LITTLEFIELD EXTERIOR

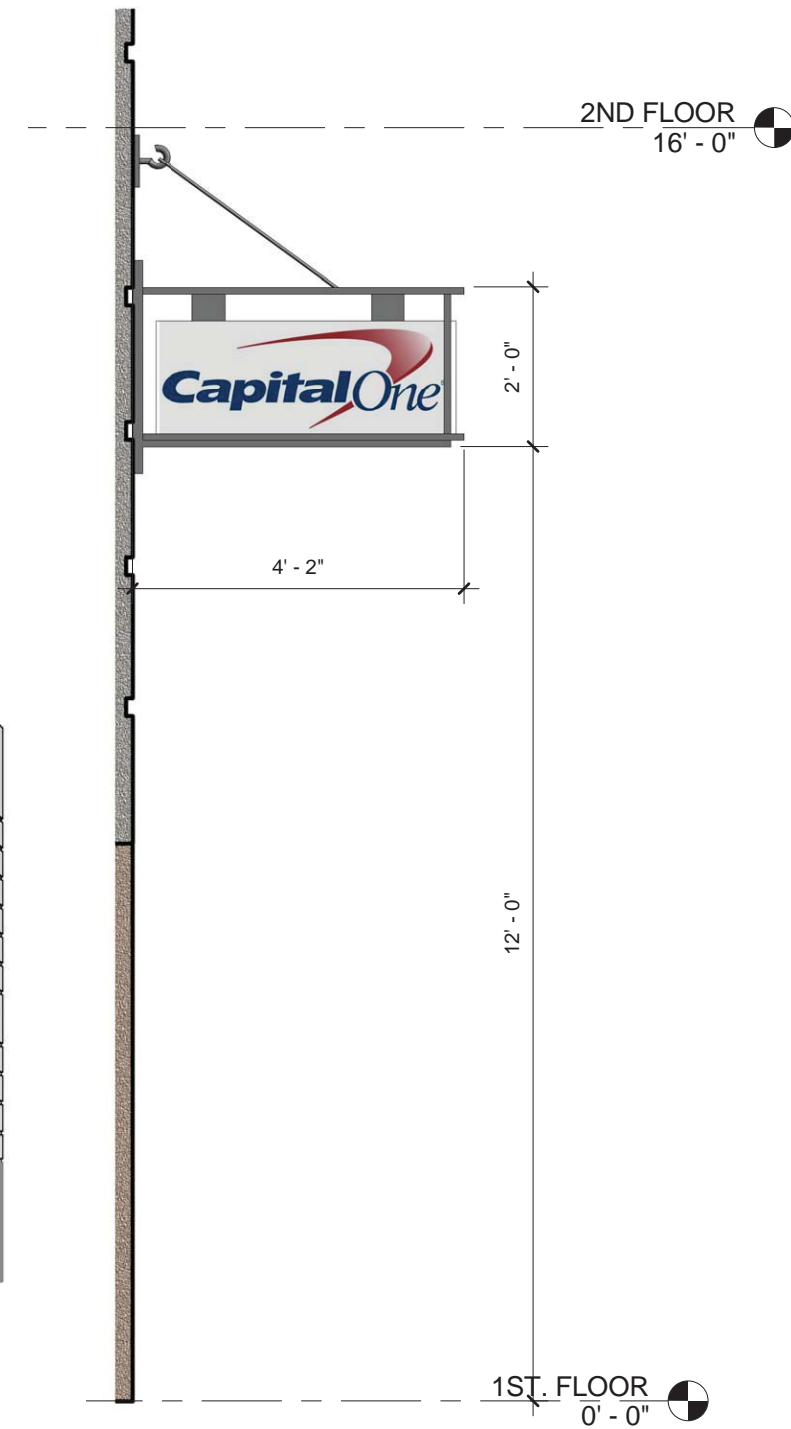
Existing Entry Door to be Replaced

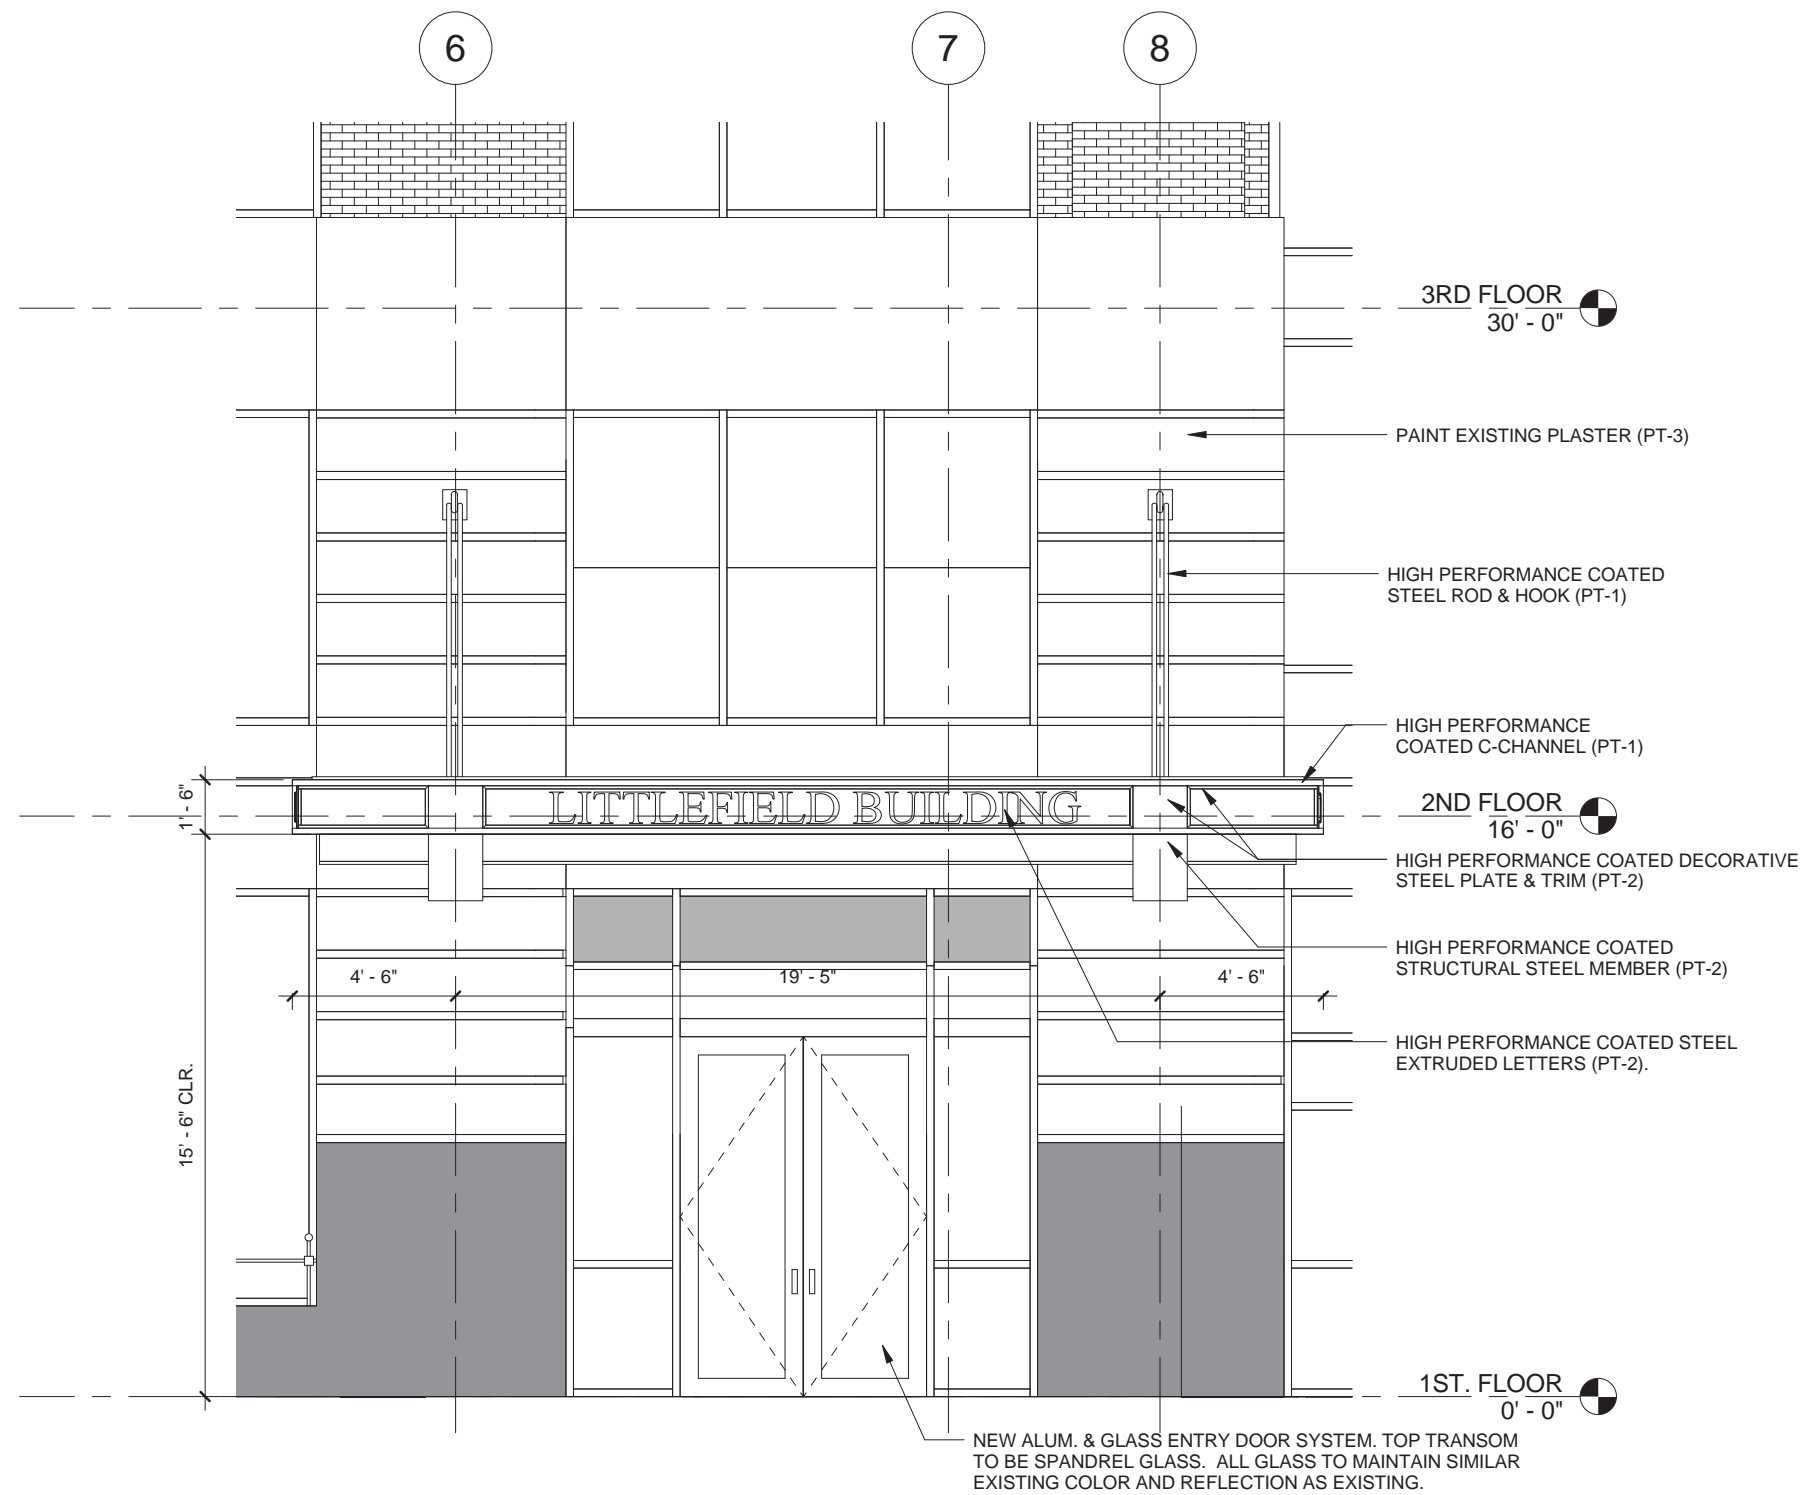
Existing Railing to be High-Perforance coated (PT-1)

Removing railing to be replaced with railing to match other existing railings
